Date of Issuance: 2.13.2025
 Project: Hyrum City – Libbie Springs Park
 Subject: Contract Document revisions & bid Questions/Responses

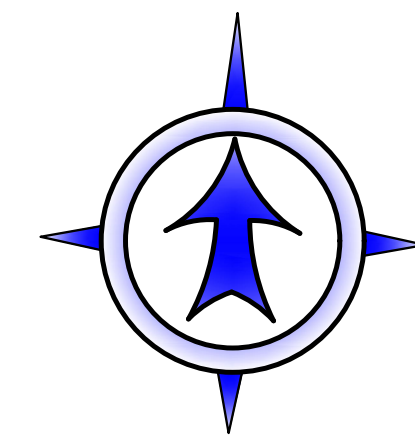
Response: If bridge manufacturer provides the engineering and states helical piles are acceptable that is okay.
7. Can you identify the location for the restroom sewer to be connected to the city main? Will the culinary water used in the restroom be supplied by the owner installed 2" water meter indicated on the plans?

Response: Sewer stub is located as shown below with green 6" tub above grade as seen on site during pre-bid meeting. Plan some exploration work to verify piping and elevations. Water meter is installed and 2" water line has been stubbed in approximate location on site as seen at pre-bid meeting. Watched for additional information in addendum #2.
